South Holland
Drainage Board

RE: Consent to relax Byelaw 10 (no works within 9 metres of the edge of drainage / flood risk management infrastructure), culverting of a 28 metre length of watercourse (Section 23 Land Drainage Act 1991) and surface water discharge (Byelaw 3) at maximum rate 2.5 l/s from a new residential development into Board-maintained Foxes Low Drain, Holbeach

Consent numbers: 19_01925_C – surface water discharge (Byelaw 3)
19_01926_C – alteration of watercourse (Byelaw 4 & Section 23
Land Drainage Act 1991)
20_02868_C – works within 9 metres of Board's watercourse
(Byelaw 10)

Location: Land off Balmoral Way, Holbeach

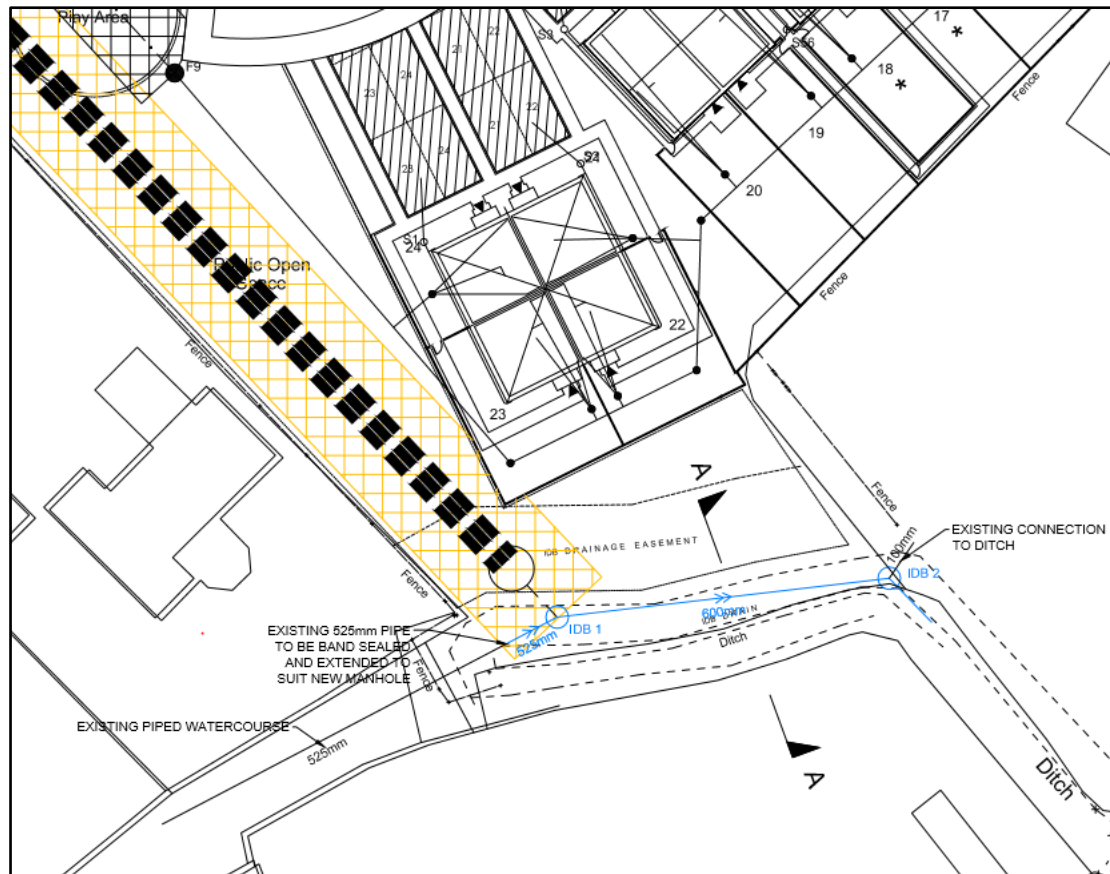
- S1 Culvert size: The open watercourse is to be culverted for 28 metres from approximate grid reference 537175, 325220 to 537205, 325226, as shown in Drawing no. AHL-1437-01-DR-013 P1 (Inspire Design & Development, 3/3/20). The culvert shall be constructed using a 600 mm internal diameter twin wall pipe (of a suitable specification) with the exception of a short upstream connection (see S3, below). The pipe size is stipulated in order that the amount of potential storage volume in the watercourse which will be lost as a result of the piping is not unacceptably high.

- S3 Culvert connection: A new length of 525 mm diameter pipe will be used to form a sealed connection with the existing Board culvert upstream of the proposed works. An inspection chamber (manhole IDB1) will be constructed at the transition point to the new 600 mm diameter pipe at grid reference 537181, 325217. The surface water system will discharge into this manhole as well (see S11, below). The new manhole must be suitably designed to allow access/egress for future maintenance operations and should be built off a reinforced cast-concrete base, a minimum of 150 mm thick, with a 200 mm deep sump below the lowest pipe

Figure 3. Proposed 600 mm diameter culvert cross-section (extract taken from Drawing no. AHL-1437-01-DR-013 P1, Inspire Design & Development, 03/03/2020)

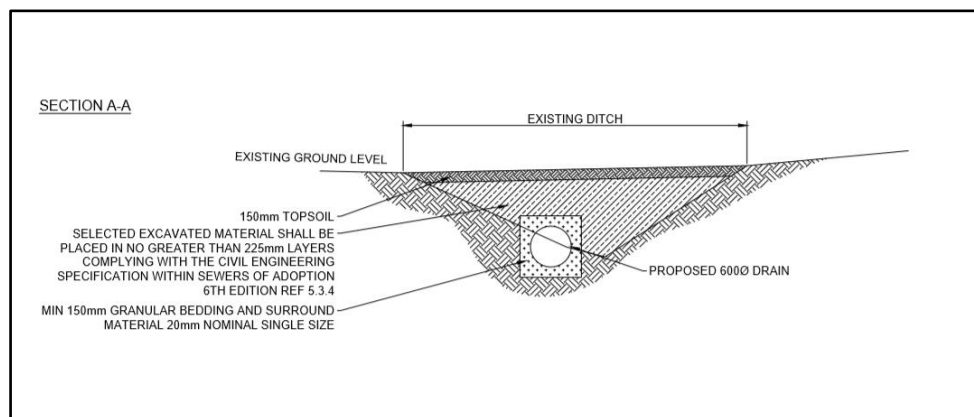
- S2 Culvert bedding: At the outset of your works you are to "clean out" the watercourse, removing the silt and other soft debris from the base of the drain, so that a firm bed level can be established (this will be required to set the invert level for your new pipe). The pipe is to be laid at a flat invert level and laid to the same level as the existing pipe invert level at 1.27m ODN (see S3, below). The new pipe should be bedded on and surrounded by 200 mm thick layer of pea gravel, surrounded by suitable permeable geotextile.

Figure 4. Inspection chamber detail (extract taken from Drawing no. AHL-1437-01-DR-013 P1, Inspire Design & Development, 3/3/2020)

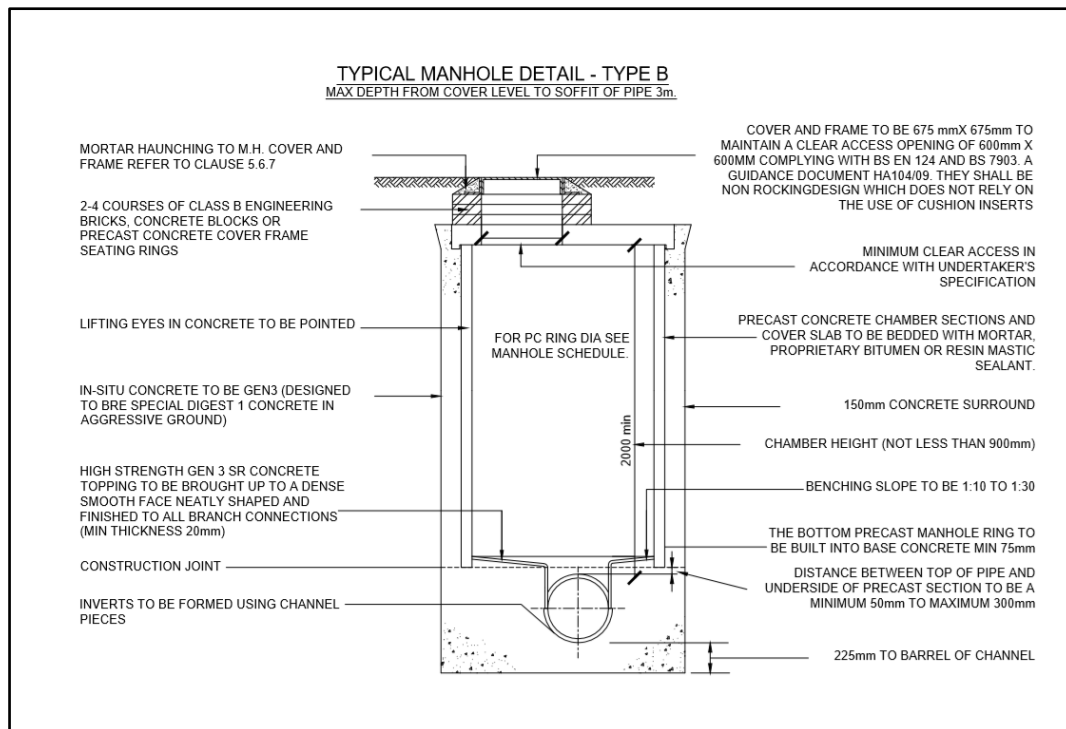
- invert level. The manhole is to be built in line with current building regulations, as shown in Drawing no. AHL-1437-01-DR-013 P1 (Inspire Design & Development, 3/3/2020), and therefore should be at least 1800 mm x 1050mm (for a rectangular chamber) or have a diameter of 1800mm (for a circular chamber). The chamber is to be built up to finished ground level, and should include a suitable reinforced concrete top slab complete with manhole covers and frame.

Figure 5. Detail of proposed boundary fencing, marked as a green line, within 9 metres of Foxes Low Drain (extract taken from Drawing no. 72-BT-01 Rev D, Ashwood Homes, June 2019)

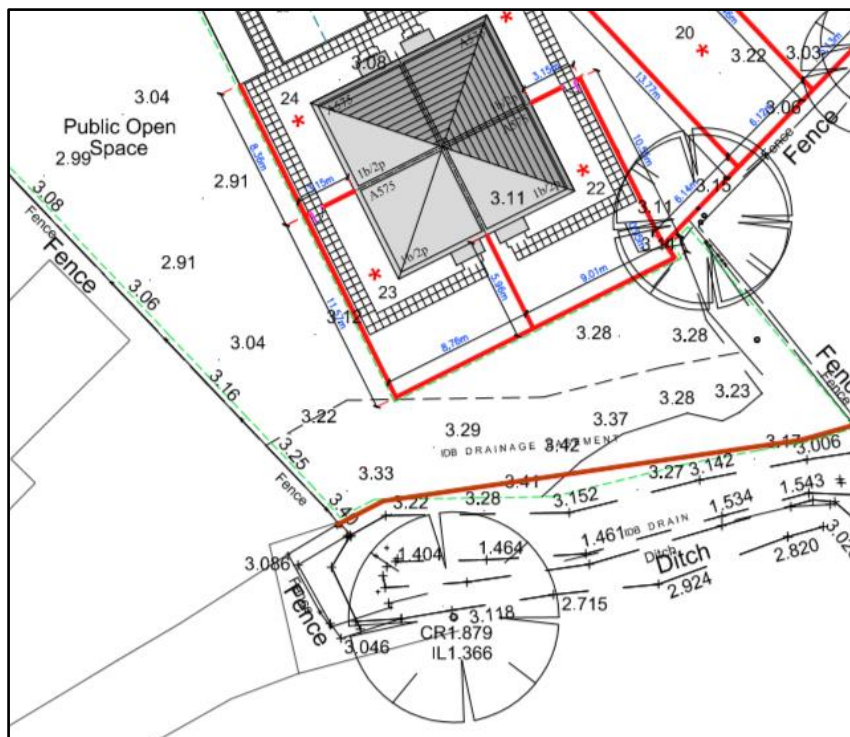
- C8 A boundary fence shall be constructed to the north of the Board's maintained watercourse to separate the Board's access strip from an area of public open space. The Board will be responsible for maintenance of the access strip between the pipe and the new boundary fence. You will be legally bound to keep and maintain the fence in good repair, and to replace it as necessary in the future when it becomes no longer fit for purpose. Responsibility for the maintenance of the land between the fence and the 9 metre byelaw easement distance will rest with yourselves and/or your successors.

- S13 Approximately 35 metres of 1.8 metre high close-boarded wooden fence is to be erected to the north of, and parallel with, the culverted watercourse from the existing boundary marker to the west (grid reference 537175, 325220) to the culvert outfall (grid reference 537207, 325225), as per Drawing no. 72-BT-01 Rev D (Ashwood Homes, June 2019).
- S14 The fencing shall be located to provide a maintenance strip approximately 4.5 metres in width, measured from the outside edge of the new culvert, for the Board's machinery requirements.
- S15 The fence posts are to be driven in, as opposed to cemented.
- S16 The Board retains the right to remove part of, or all, of the fencing if emergency access is required.
